NO CONFORMIDADES MOLDE 13B

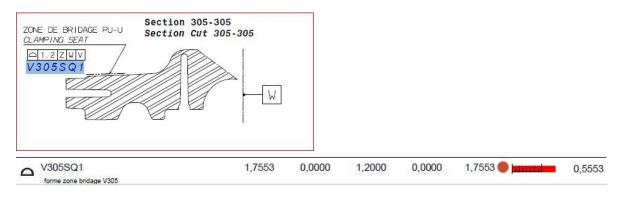
CAMBIAR PINES (3041 ENDEREZAR EN DIRECCION A LA BOMBA DE AGUA)

2042L2 loc fond 2042 / Y	119,9750	117,8000	0,9000	-0,9000	2,1750 🌑 الماليان	1,2750
CARA 300 ▶3041						
Ф 3041L4 loc 3041/ZY (19.3)	2,9627	0,0000	2,0000	0,0000	2,9627	0,9627
Ф ^{3041L4.Z}	-110,2461	-111,5000	1,0000	-1,0000	1,2539	0,2539
≥ 3041L4Z	110,2461	111,5000	1,0000	-1,0000	-1,2539 🛑 📥 🔟	-0,2539
3072L2 loc face 3072 / X	182,4472	183,3000	0,6000	-0,6000	ليليا 🛑 -0,8528 🛑	-0,2528
4104L1Z	148,3948	149,0000	0,6000	-0,6000	-0,6052 ()	-0,0052
♦ 4104L1 loc 4104 / ZX (4,98)	1,2162	0,0000	1,2000	0,0000	1,2162	0,0162
Ф ^{4104L1.Z}	-148,3948	-149,0000	0,6000	-0,6000	0,6052	0,0052
● 6070L2	190,7675	192,0000	0,9000	-0,9000	-1,2325 🔴 📥 🕕	-0,3325
loc fond 6070 / Y

V305SQ1 LIMPIAR ZONA

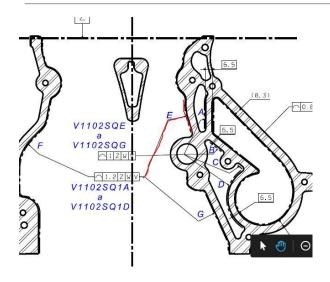
LIMPIAR ZONA

LIMPIAR ZONA

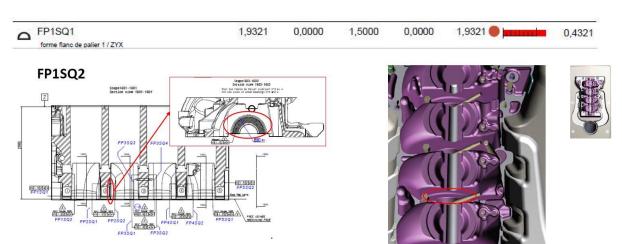
Faltas material pieza:

Exceso material pieza:
